## Addendum 2

## SP-4 TRENCHLESS INSTALLATION OF UTILITIES - FREE BORE

EB-5819 12/1/22

Drawing Name
ELECTRICAL
PLAN

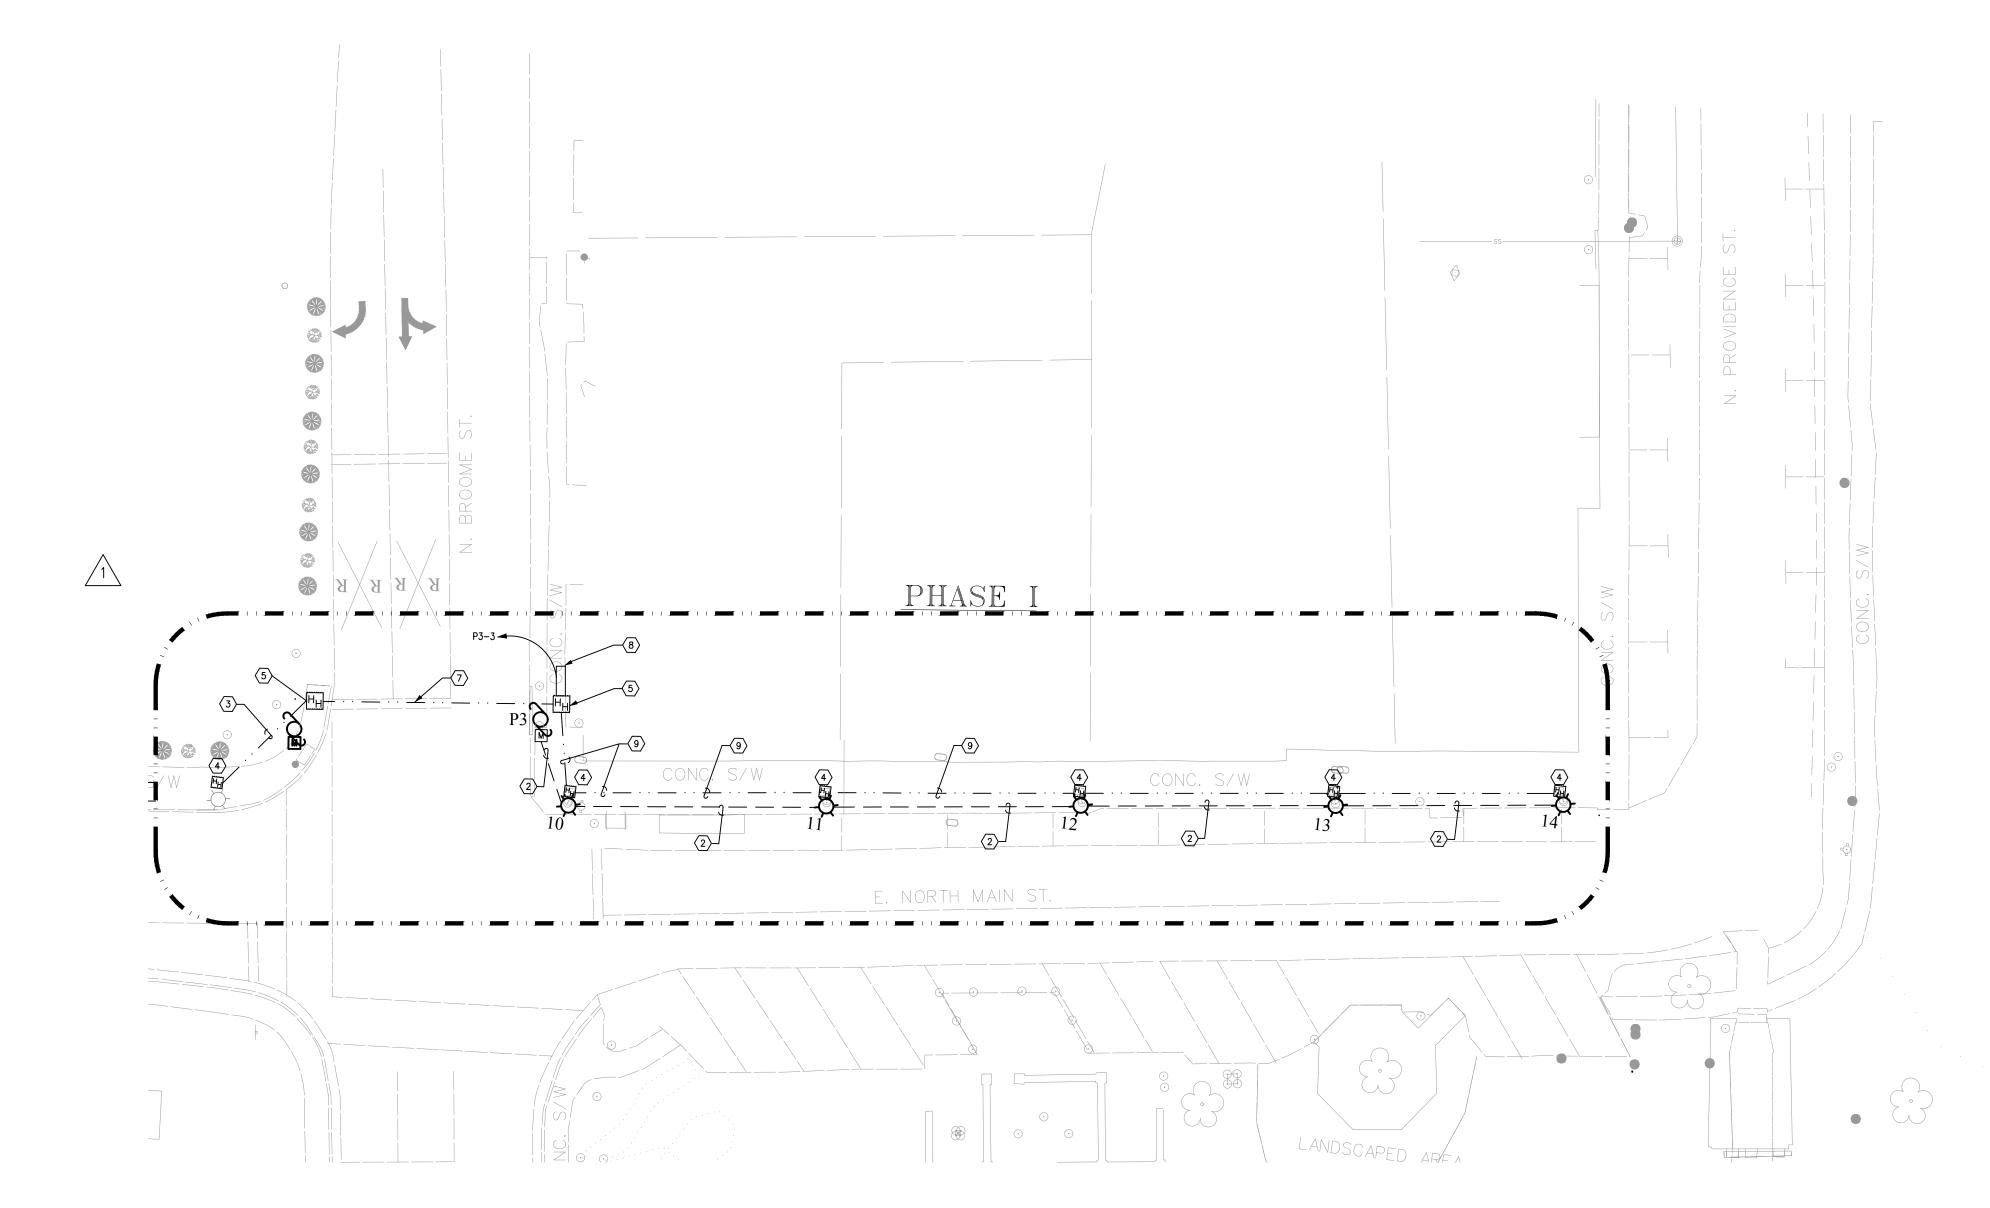
- **5.** *Plan Sheet E 1.0-Electrical Plan* has been revised to update the <u>Pole Schedule</u> and the <u>Plan Specific Notes</u>.
- **6.** Question- The pavement schedule on sheets 2A and 2B have different thicknesses for E1, D1, & C1. Please clarify. Answer- Use the pavement schedule on 2A for the project. Some clarification on C1- S9.5B
